Service Bulletin

Subject: POPPING AND/OR SQUEAKING NOISE FROM FRONT SHOCK ABSORBER AND/OR CREAKING NOISE FROM FRONT LOWER ARM BUSHING	Bulletin No: 02-001/16
	Last Issued: 02/23/2016

This bulletin supersedes the previously issued bulletin(s) listed below. The changes are noted below in Red beside the change bars.

Bump Stopper Replacement

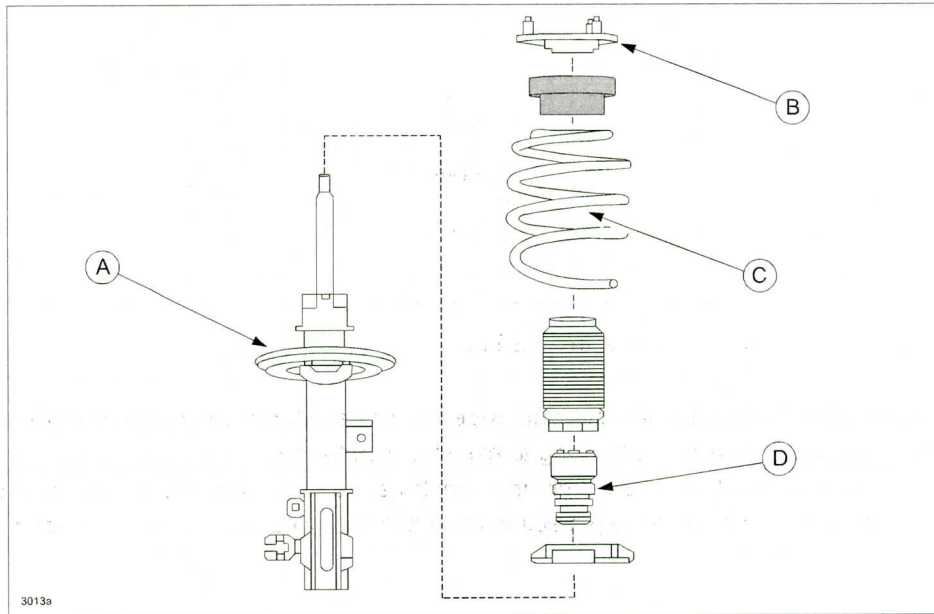
- For the squeaking and popping noise, the shape of the bump stopper has been modified and a protector has been installed onto the coil spring.
- For the creaking noise, the friction of the lower arm bushing has been reduced by adding a dry coating.

1. Replace the bump stopper with the modified one according to MS3 online instructions or the Workshop Manual (section 02-13 FRONT SHOCK ABSORBER AND COIL SPRING DISASSEMBLY/ASSEMBLY).

- Before removing the mounting rubber, mark its original position so it can be re-installed later to the same position.
- When replacing the bump stopper with a modified one, apply grease to upper side of the bump stopper and to the inside of the bump stopper (on the surface that contacts the damper rod).

New Part Number	Old Part Number	Description	Qty	Notes
B45A-34-111A	B45A-34-111	Stopper, Bump	2	For Japan built 2.0L B4YA-34-111 (Service Part) can also be used.
B45G-34-111A	B45G-34-111	Stopper, Bump	2	For Japan built 2.5L B4YG-34-111 (Service Part) can also be used.
KDY5-34-081	--	Protector	2	All models
9YB0-41-237	--	Piston Rod Nut	2	All models
KD35-34-470C	--	Front Lower Arm Bushing	2	For Japan built KDY5-34-470A (Service Part) can also be used.

Lower Arm Bushing Replacement

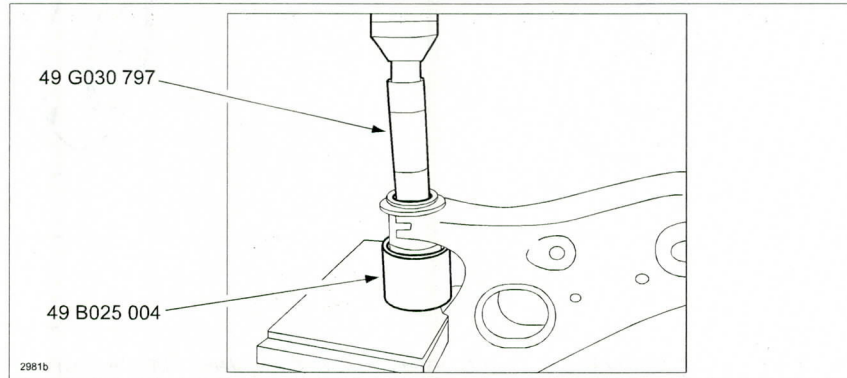
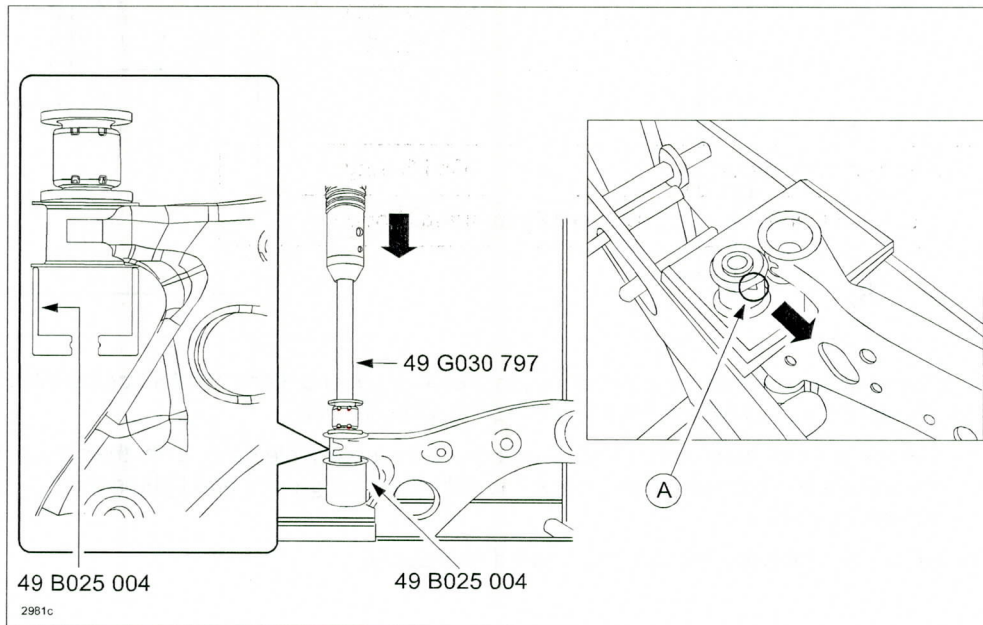
CAUTION: Installation of the modified lower arm bushing will affect the road noise and the riding comfort in a negative way. Therefore, only use this modified part for a customer vehicle with consideration of these adverse effects.
